Comments [rv. 1] from S. D Hovorka, University of Texas at Austin, On Draft Accounting and Permanence Protocol for Carbon Capture and Geologic Sequestration under Low Carbon Full Standard.

Fig. 10 Time evolution of the CO₂ mass distribution for the entire model for the base-case (thick lines) and sensitivity-study case SH4, which models the Vedder Formation as a homogeneous, isotropic sand (thin lines)

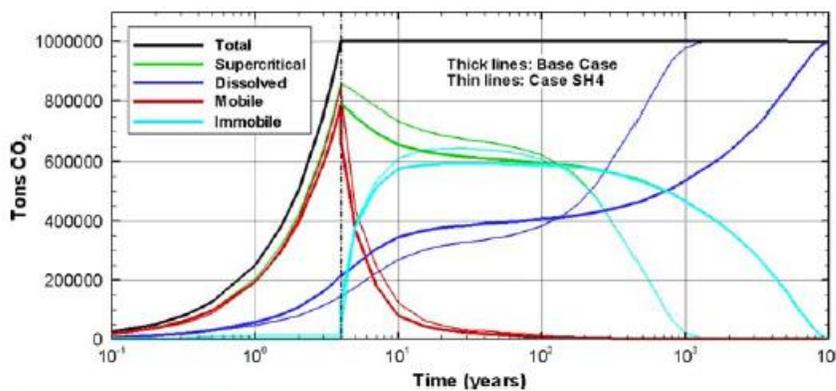
It is important to qualify what is meant by “plume movement ceases” and “pressure differentials”. Stabilization is asymptotic, most of the stabilization occurs in a few years, but slight adjustments will continue to occur for 1000’s of years as shown in this figure.

Qualification might be “plume on a trend toward a stable configuration”. Because CO₂ is buoyant, if it is in a structural trap, it will always be capable of migrating vertically. Pressure equilibration is asymptotic also.
